February 12, 2024

RE: 14 Tallwoods Road
Christian Jungers & Michelle Starr
14 Tallwoods
Tax ID – Section 107.02, Block 1, Lot 17

This office is pleased to provide updated plans in support of the Christian Jungers and Michelle Starr Site Plan, Wetland, Steep Slope and Tree Removal approvals related to the proposed swimming pool at 14 Tallwoods Road. Plans have been updated and supplemental information provided to address the conditions of the Resolution of Approval. Plans and comments have been addressed as follows:

POOL RETAINING WALL PLAN,
SECTION AND DETAILS

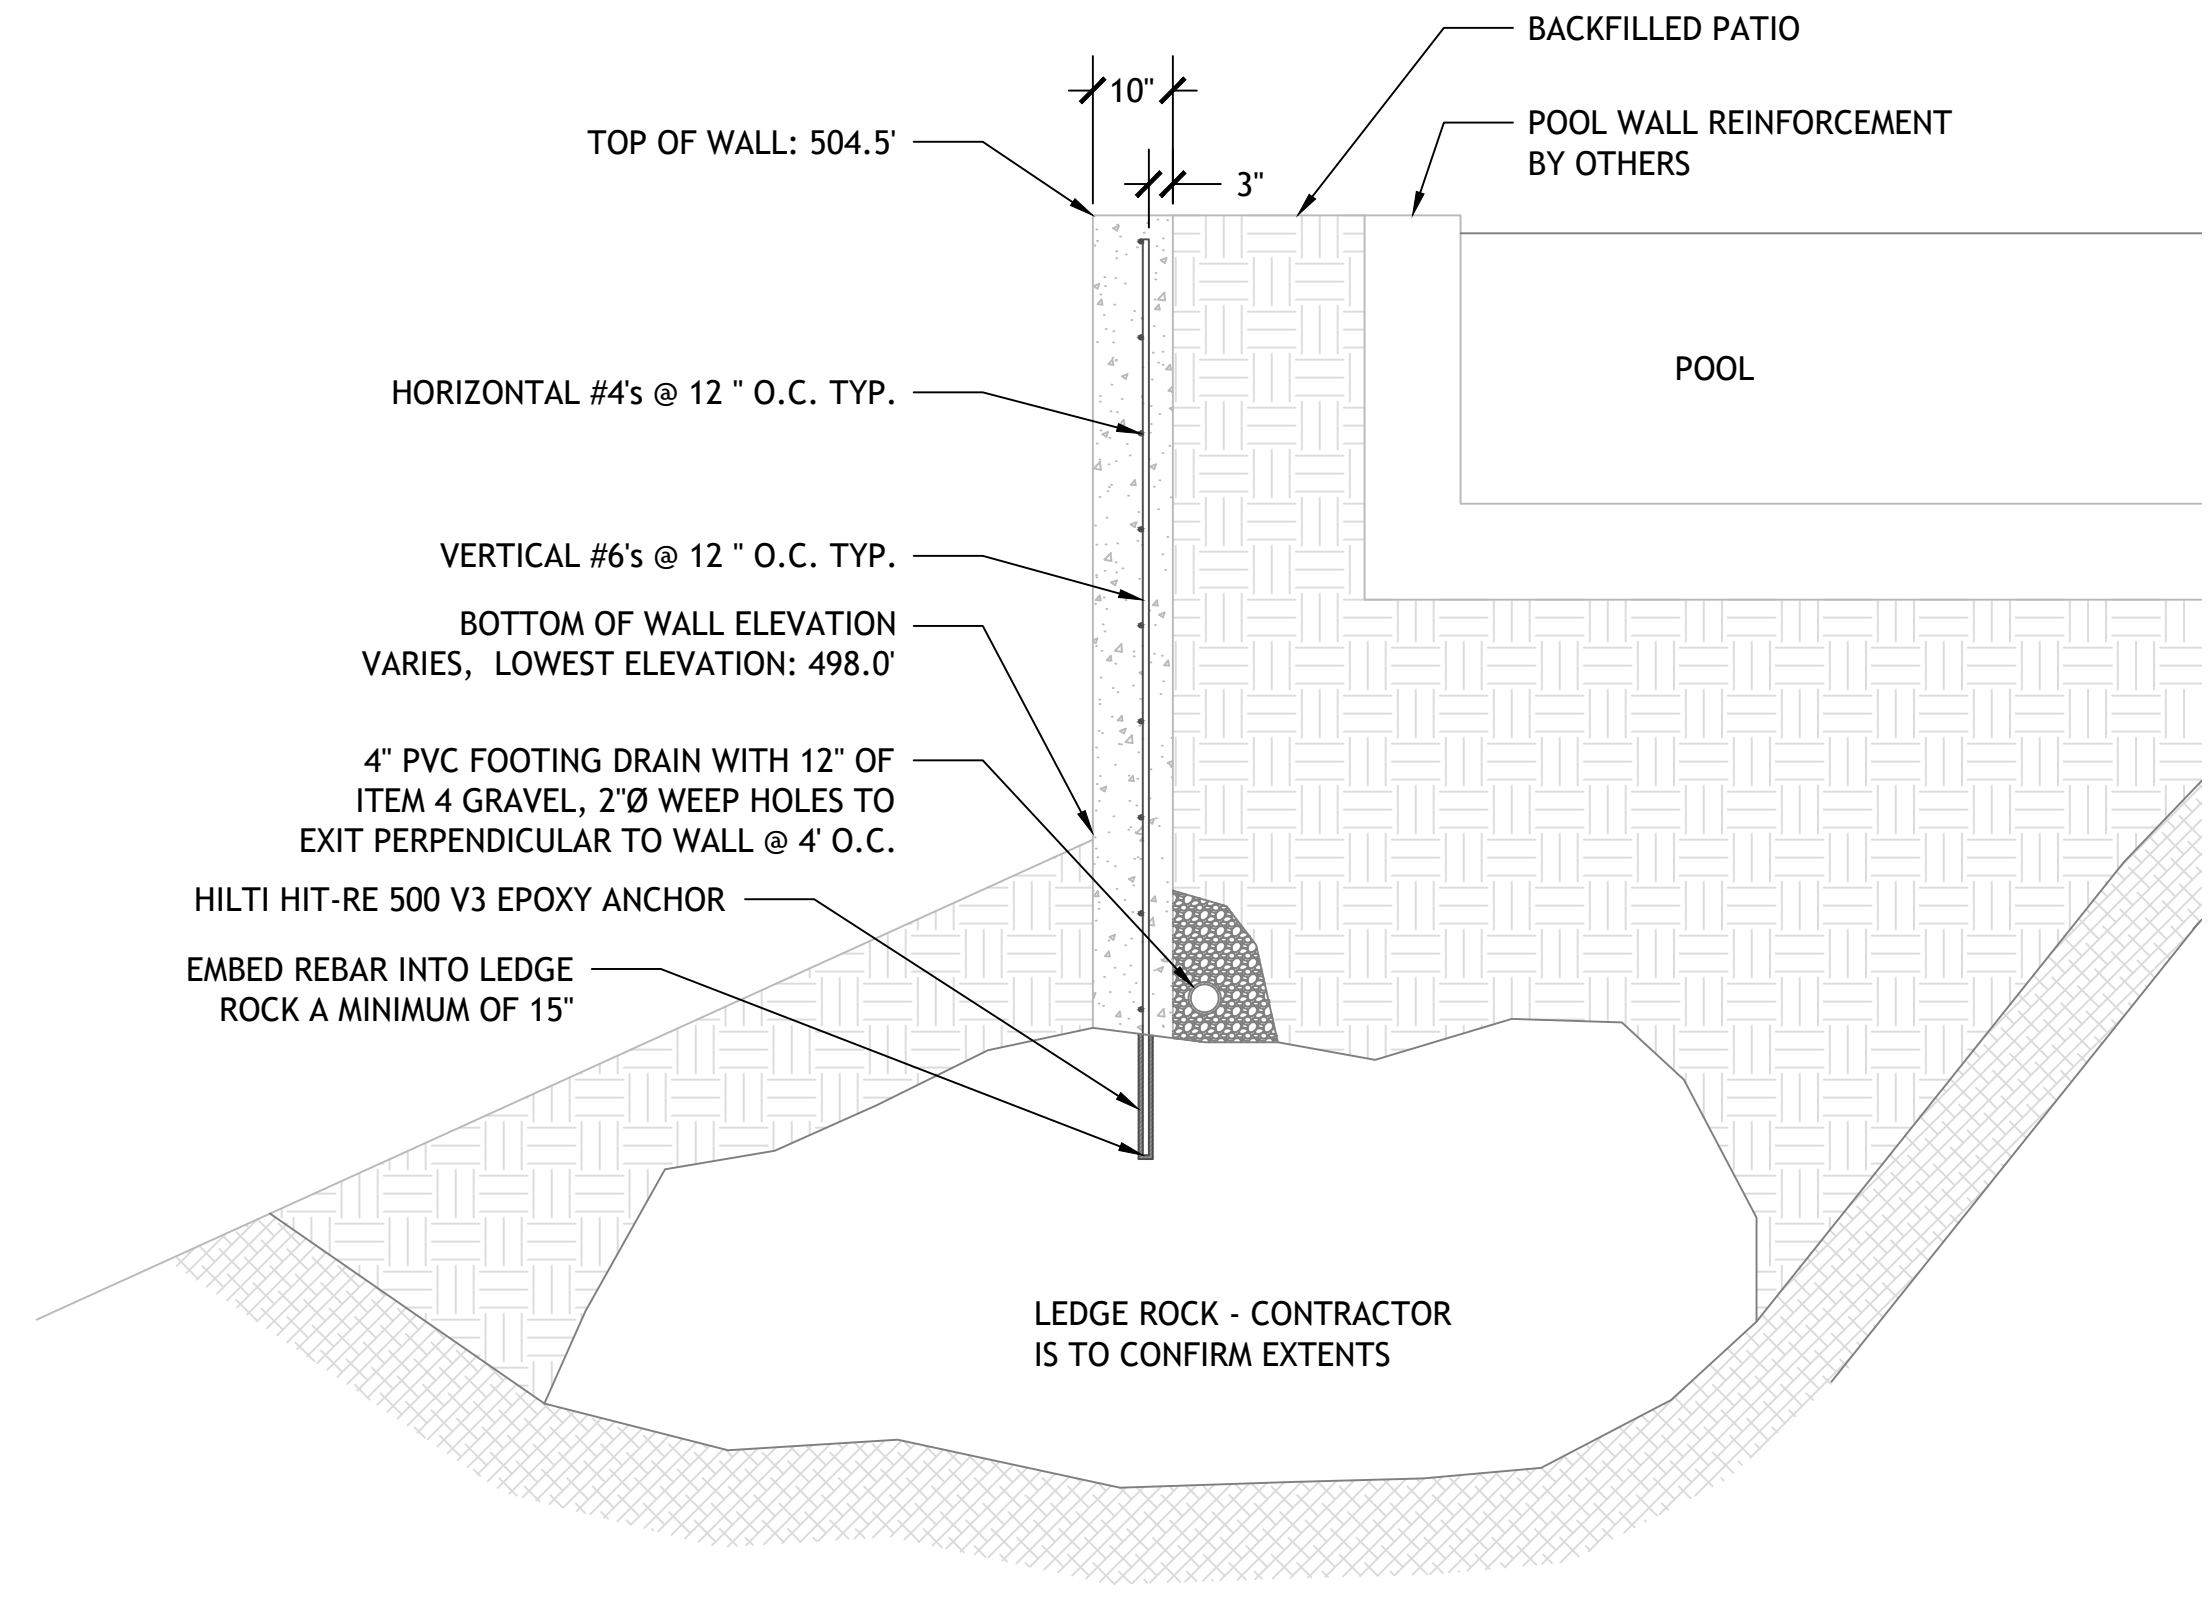
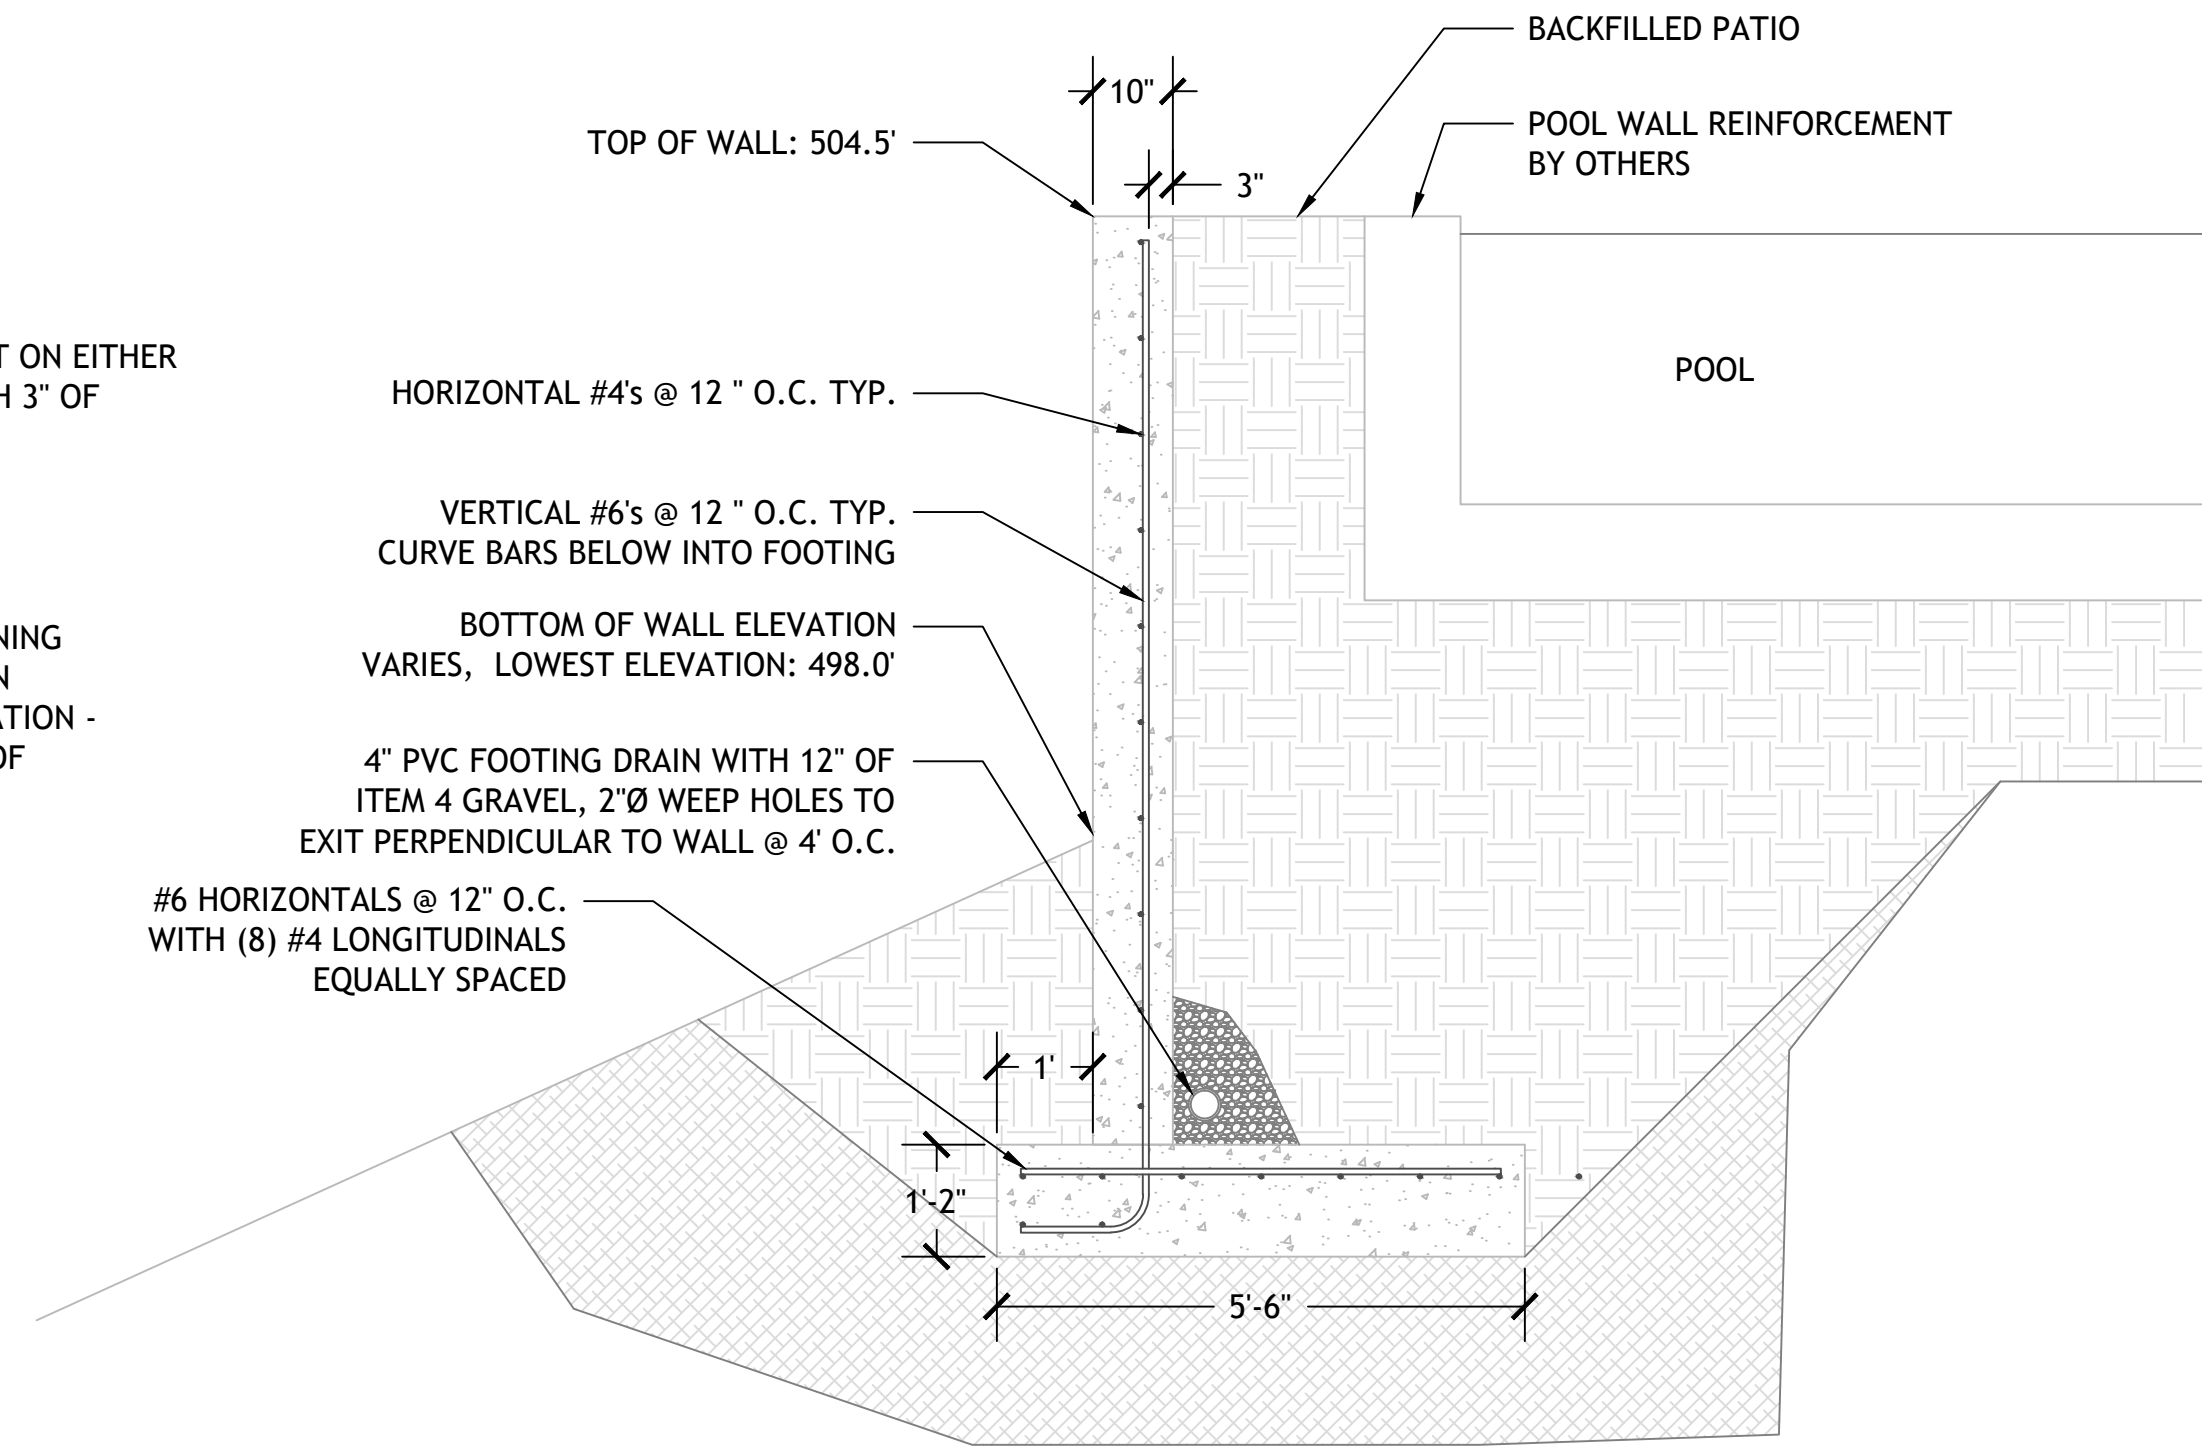
1. *The applicant shall provide construction details of the retaining wall, inclusive of design calculations for bearing, sliding and overturning to the satisfaction of the Town Engineer.*

Response: Retaining wall Construction plans with details have been prepared and are attached for review by the Town Engineer.
